PLANNING AND COMMUNITY DEVELOPMENT DIRECTOR APPROVAL

MICAH JEUB  
 GLAMPING II  
 SITE DEVELOPMENT PLAN

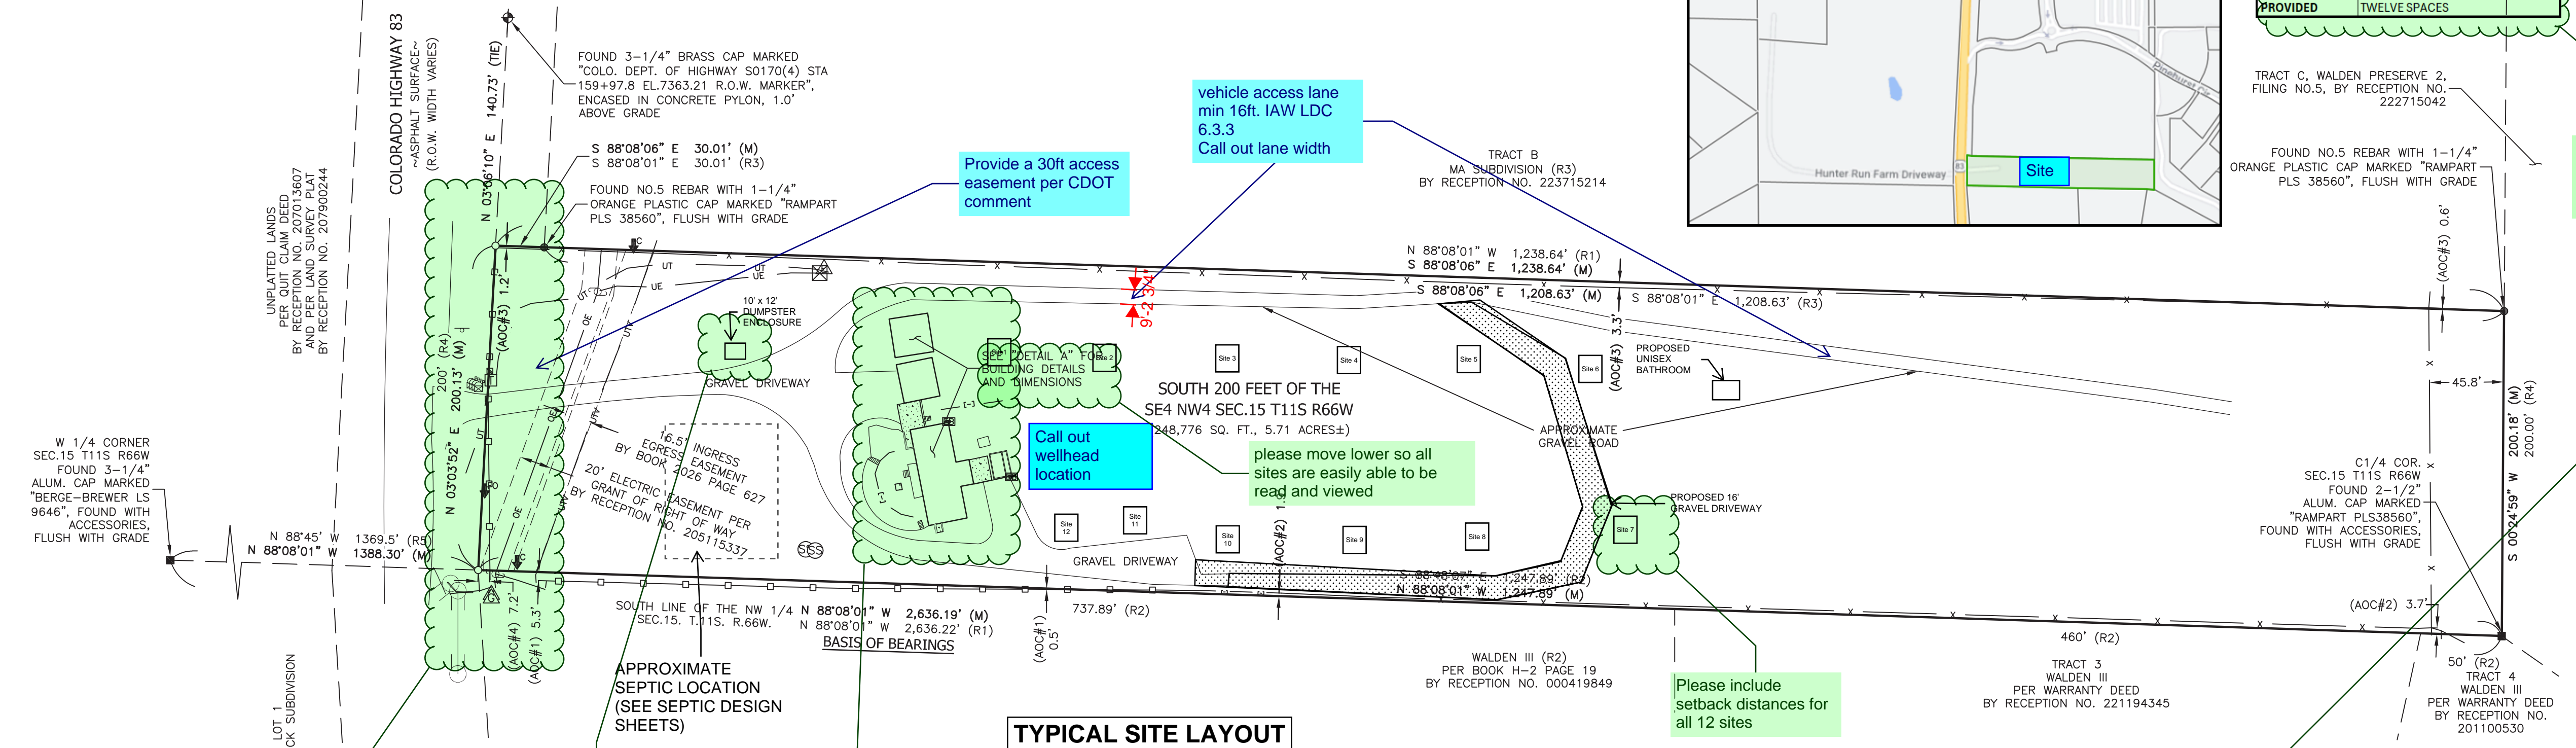
At a minimum 1 ADA space must be provided, please adjust accordingly

vehicle access lane min 16ft. IAW LDC 6.3.3 Call out lane width  
 Provide a 30ft access easement per CDOT comment

Call out wellhead location  
 please move lower so all sites are easily able to be read and viewed

Please include setback distances for all 12 sites

Please include sight distance triangles and any signs, plantings, or other visual obstructions if applicable

Please include setback distances to property lines

Please include setback distances to property lines

**TYPICAL SITE LAYOUT**

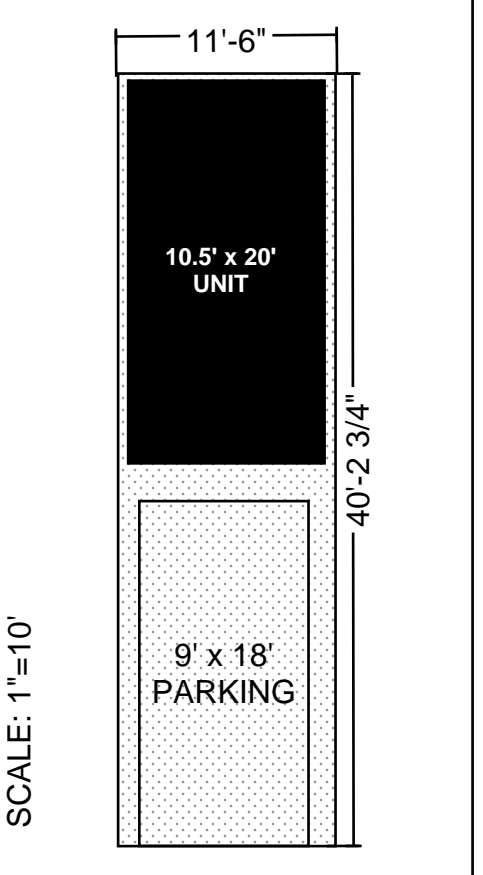
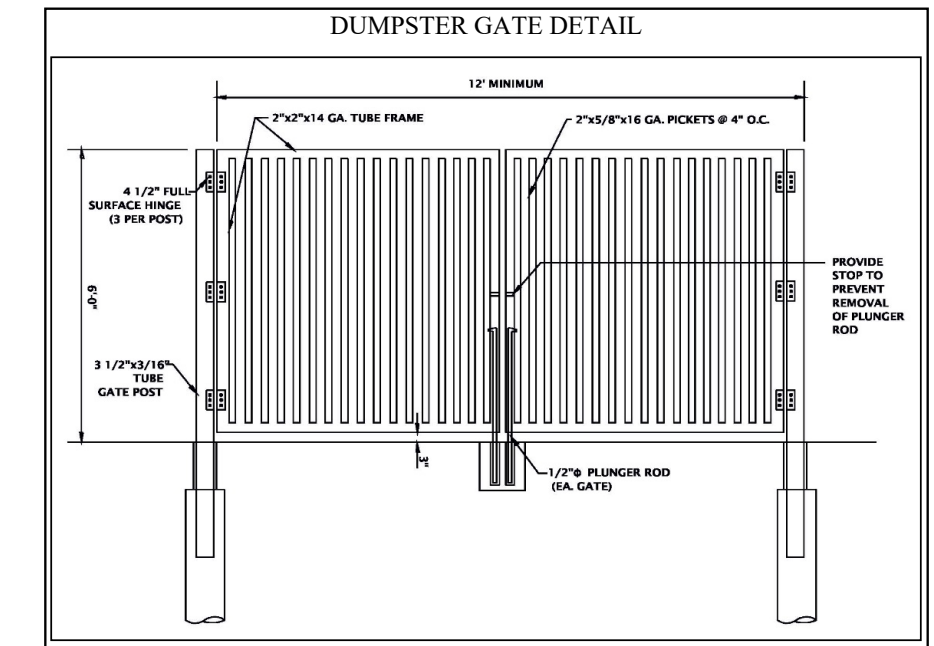
Please include:  
 -Location of no build areas, if none then specify  
 -Location of all sidewalks, trails, fences and walls, retaining walls, or berms  
 -Location and dimensions of all existing and proposed signage on site  
 -Traffic ingress and egress into the property  
 -The layout and location of all off-street parking, loading and other vehicular use areas, if none, then specify  
 -Suggestion: to add more ADA compliance items to the site such as:  
 .paved driveway that provides access to sites  
 .multiple ADA parking spaces that are paved
